DEPARTMENT OF ADMINISTRATIVE SERVICES

I-23-01

Request for Formal Interpretation of the 2022 Connecticut State Building Code

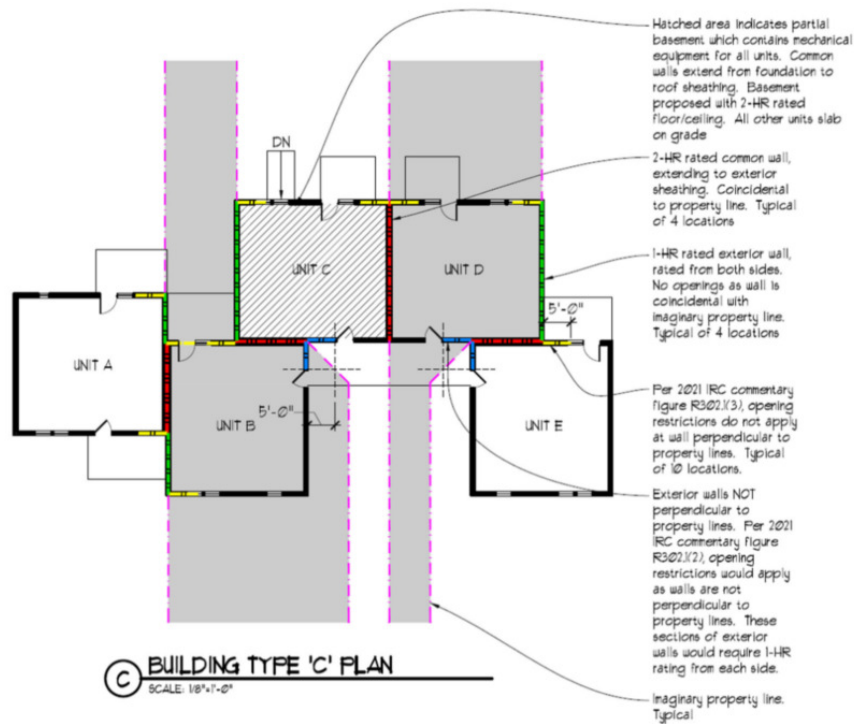
We also would like clarification if we meet the intent of a "townhouse" unit as there will be a partial basement with equipment that services all units within the structure. See figure on following page for clarification.

If the wall extends all the way to foundation and up to roof deck, this meets the intent of the townhouse definition as described.
